## IGEM/UP/10 Edition 4 - Interpretation of Clause 8.7.3.4 and Figure 7

This Infosheet is created to address an issue raised regarding clause 8.7.3.4 and figure 7 in UP/10 and it outlines IGEM's response to the issue. This is intended to help professionals make decisions about installing flued gas appliances in industrial and commercial premises.

The original graph and diagram of figure 7 published in UP/10

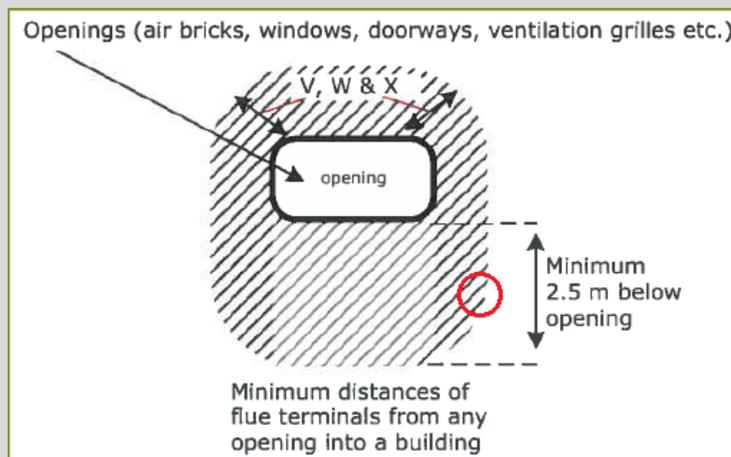
An issue has been raised with IGEM about the interpretation of clause 8.7.3.4 and figure 7 (page 39) for installations where a horizontal flue termination is lower than an opening. Figure 7 shows shaded areas around an opening in which flue terminations must not be positioned.

This has raised issues for an ICOM member, in a case where a terminal had been positioned below the opening and within distance X of a line dropped vertically down from the right-hand side of the opening (which is less than 2.5m, indicated by the red circle), and compliance was disputed.

ICOM members unanimously agree on the above response and would like to see figure 7 amended to show the squared corners shaded area forming a rectangle below the opening, rather than rounded corners.

*"The view is that "X" is not a diagonal dimension but a horizontal (or vertical) distance from the terminal, i.e. a terminal must be below 2.5m below an opening and outside a band "X" from the edge of the opening, meaning that the prohibited area below an opening is the width of "X" horizontally and 2.5m vertically.*

*Figure 7 is a bit confusing, the radius at the top of the opening is OK but below it should be a square (the radius as shown isn't from the opening so it would be difficult to apply because of the 2.5 min distance)."*
